REQUEST FOR TENDER RFT #B25-03

Washroom Upgrades
(Fenelon Twp PS, Bobcaygeon PS, IE Weldon SS, Lady Mackenzie PS)

TLDSB ADDENDUM NO. 7

RFT B25-03 LADY
MACKENZIE PUBLIC
SCHOOL

ASK 001

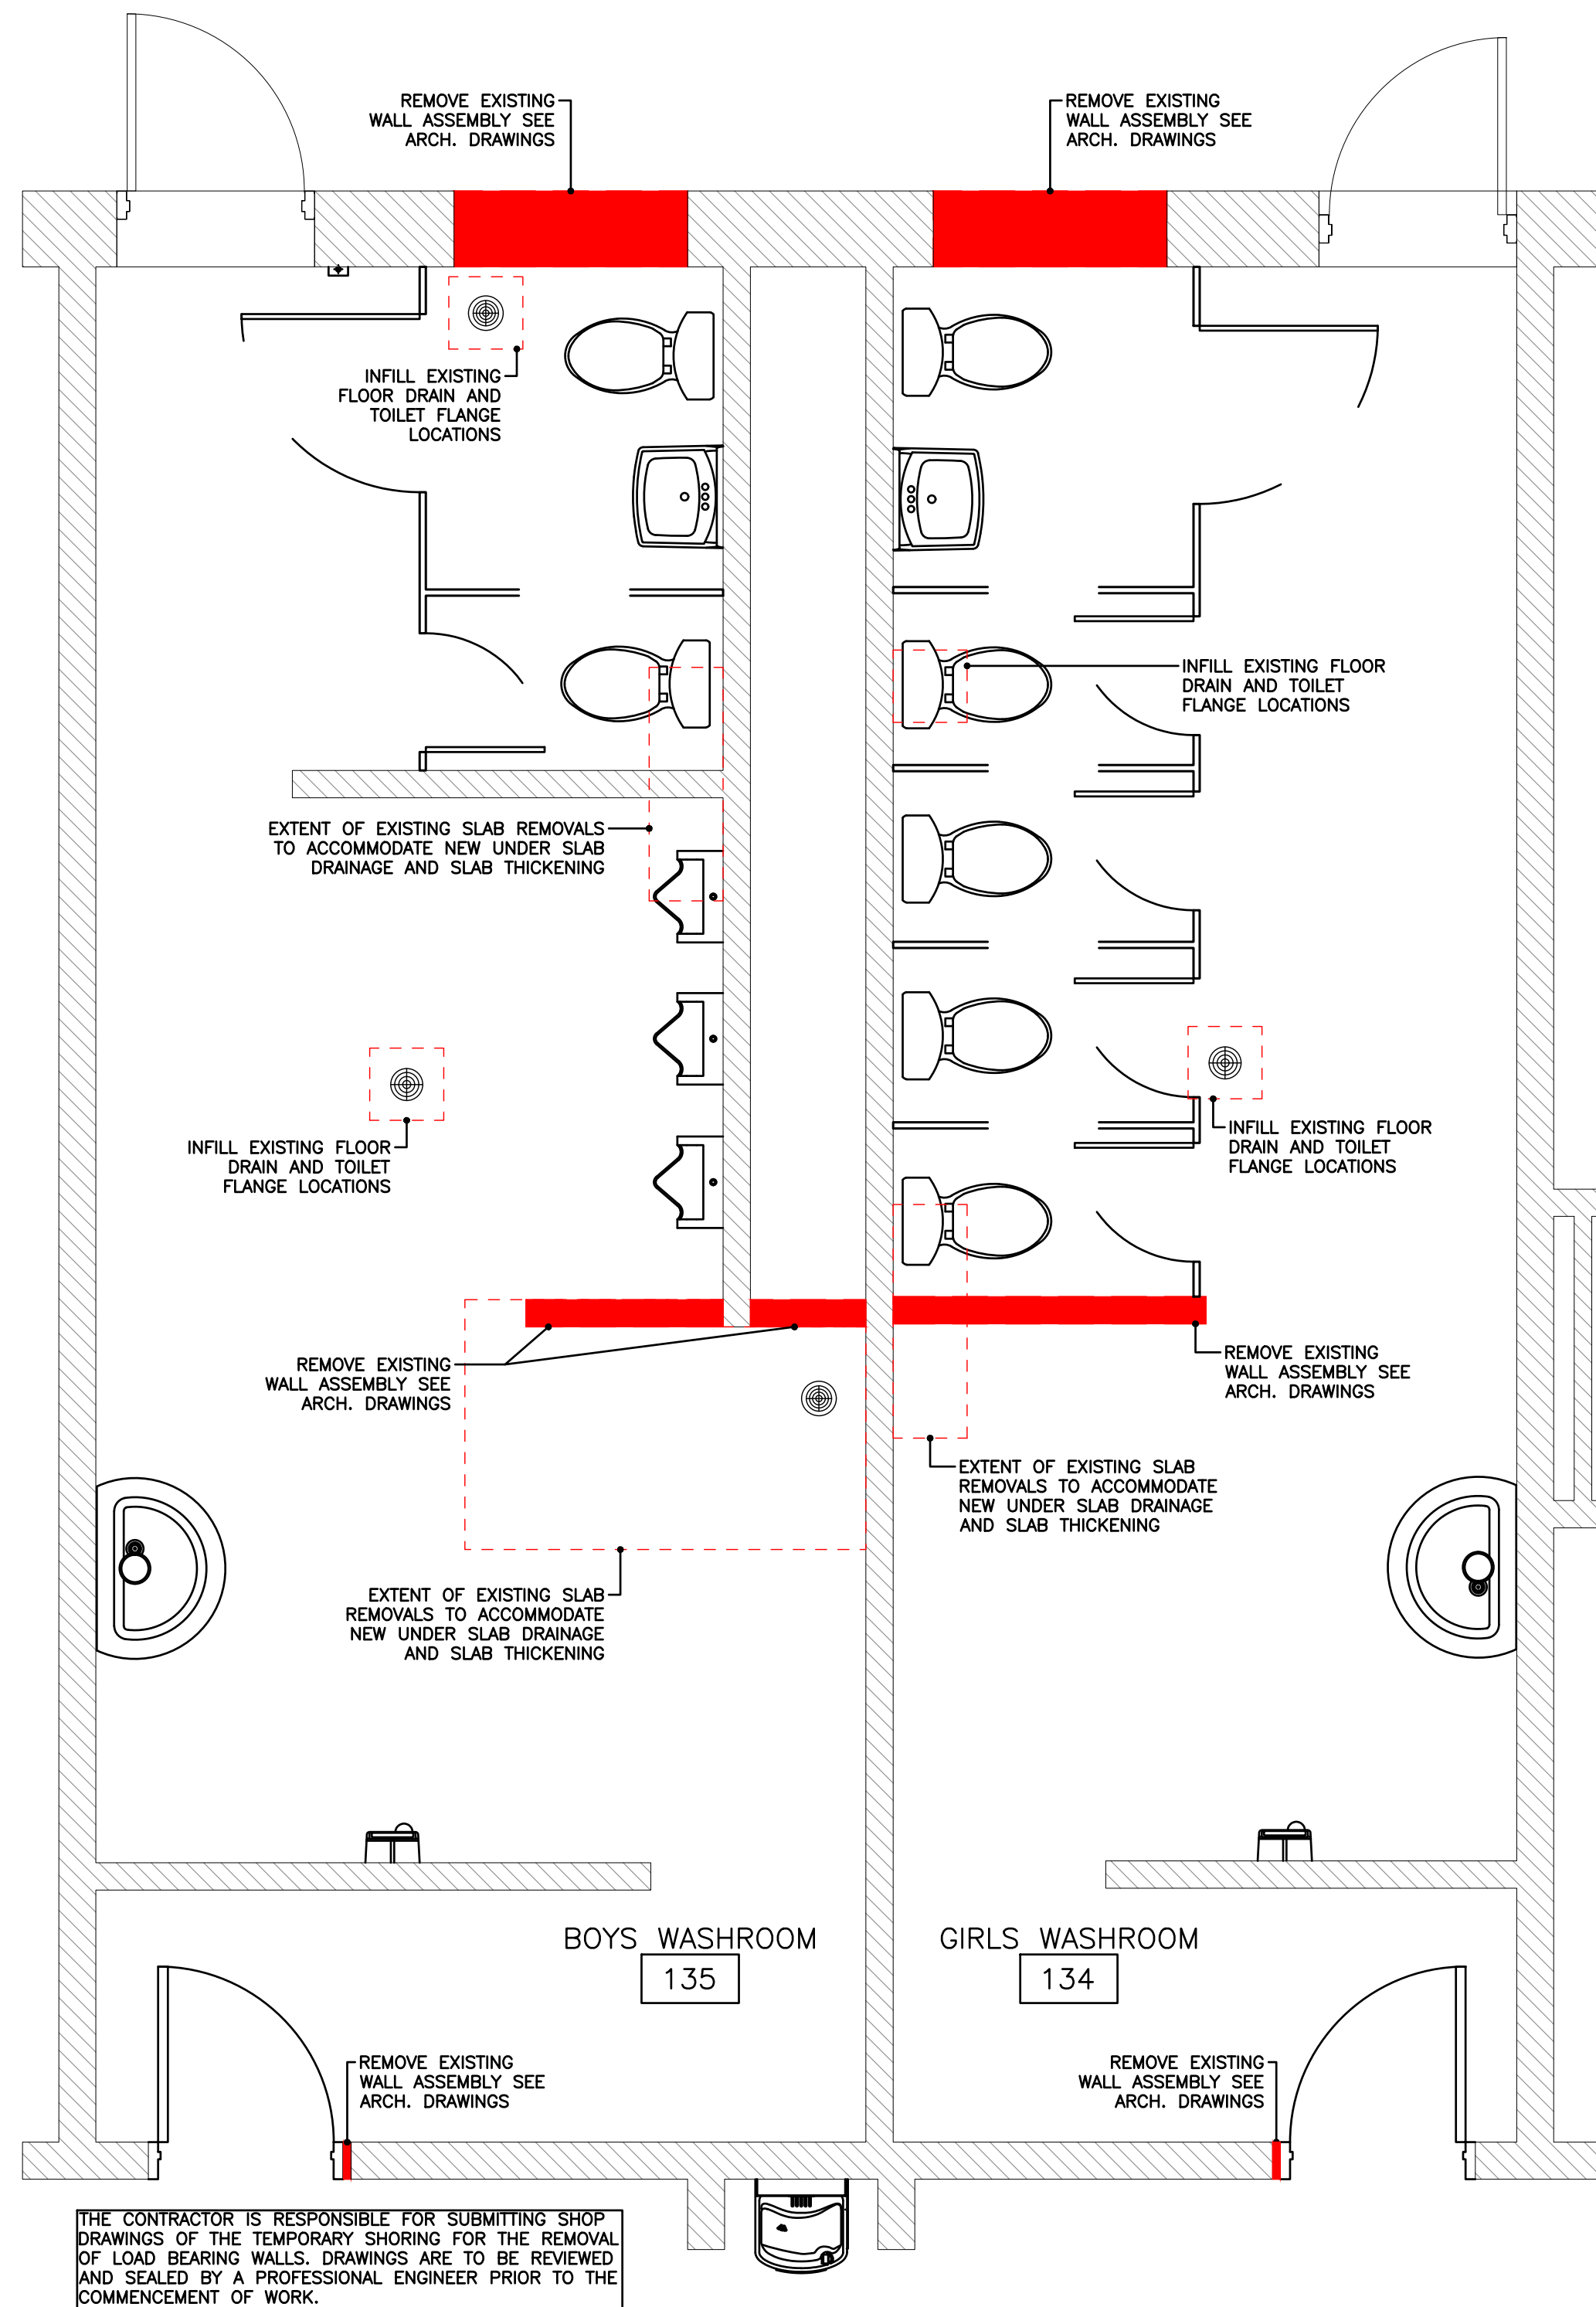
- 3.1. **ADD: Additional lintel to support the outer wythe of the masonry veneer. Refer to attached revised structural drawings S1 and S3.**
- 3.2 **Drawing 4/A800. Refer to attached ASK 001 which revises drawing 4/A800 and the new windows.**

- 3.2.1 REVISE: Window dimensions from 1200mm wide x 1000mm high to 1000mm wide x 900 high. This applies to both windows.**
 - 3.2.2. REVISE: Window to be divided into two modules. The upper module is to be an operable sash “awning” type c/w opening limiter to 100mm, refer to Specifications for “Glass Vent” requirements. The lower module is to be a fixed glazed unit. The glazing types for both units remains unchanged including privacy etching – refer to Specifications.**

- 3.2.3 REVISE: Head height of both windows to align with the adjacent exit doors and the underside of the existing masonry belt course. Existing belt course and existing split face masonry to be salvaged for reuse in New Work. Bidders are to include for 25% new block material in each type in the event of breakage during removal.**

DRAWING TITLE:
**RFT B25-03 STRUCTURAL
UPGRADE AND REPAIRS -
ROOM 134 AND 135**

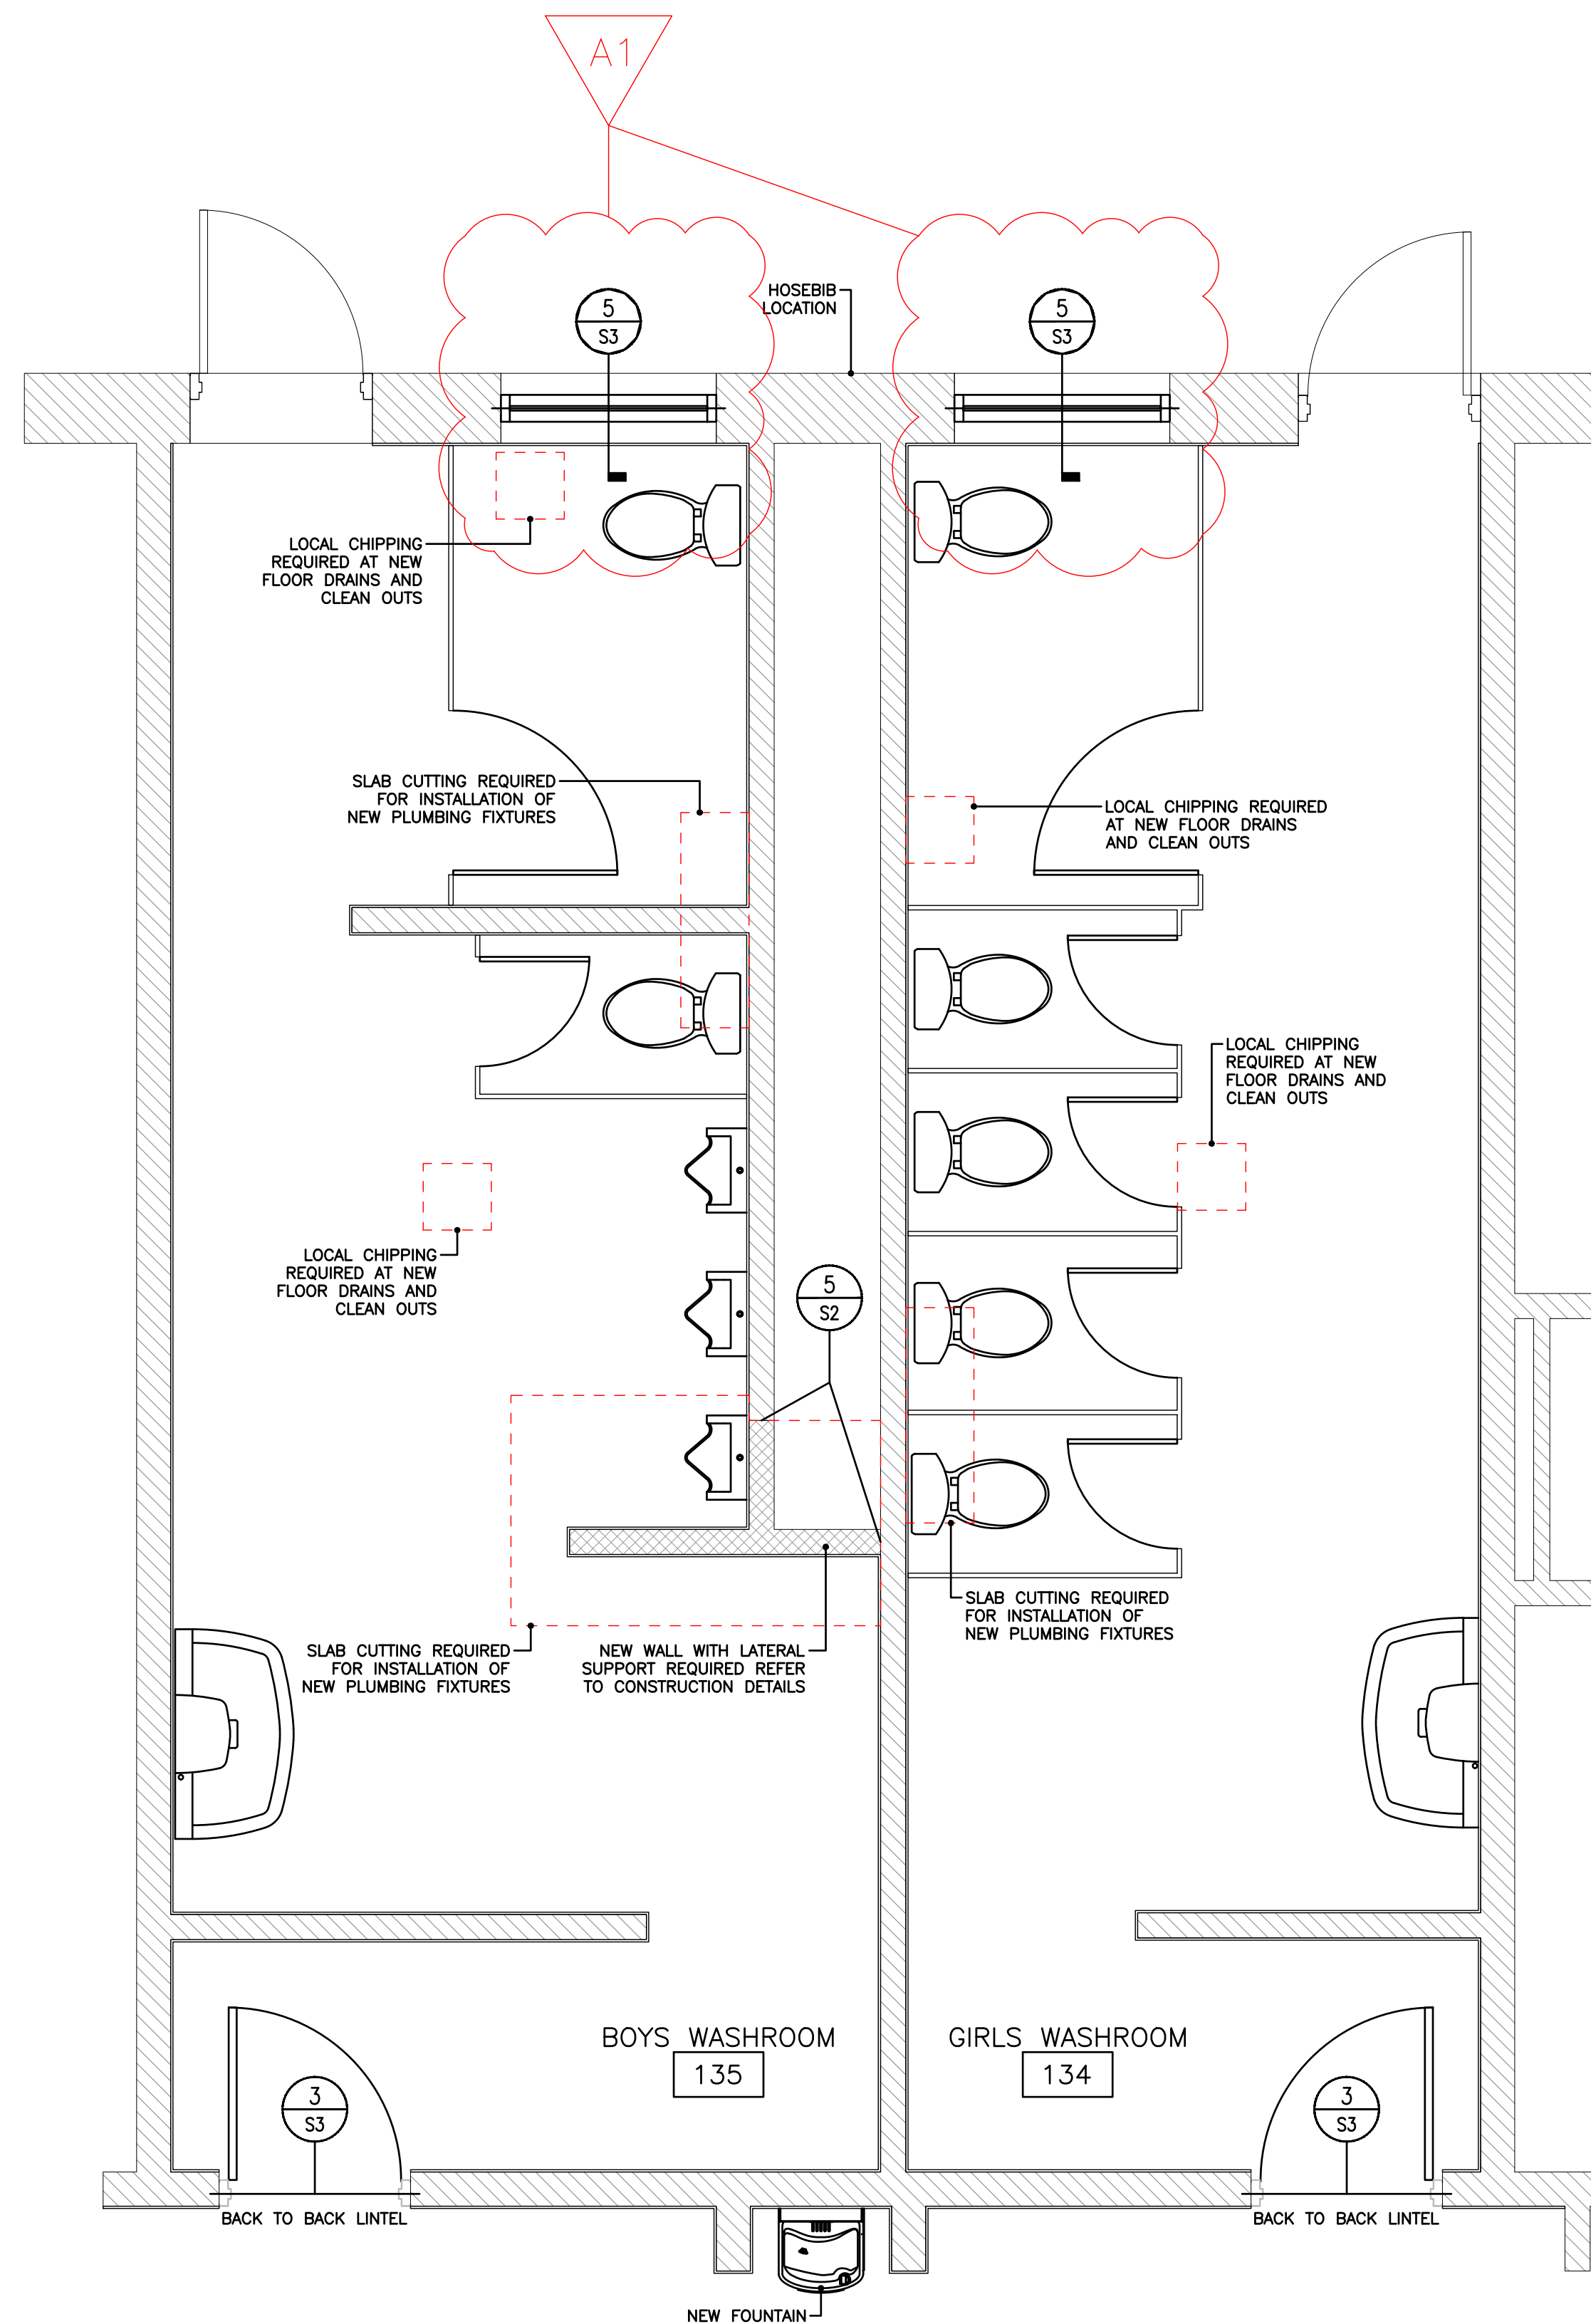
3.3.4. A reminder that engineered shoring of the existing loadbearing masonry walls is a requirement. Refer to structural for complete information.
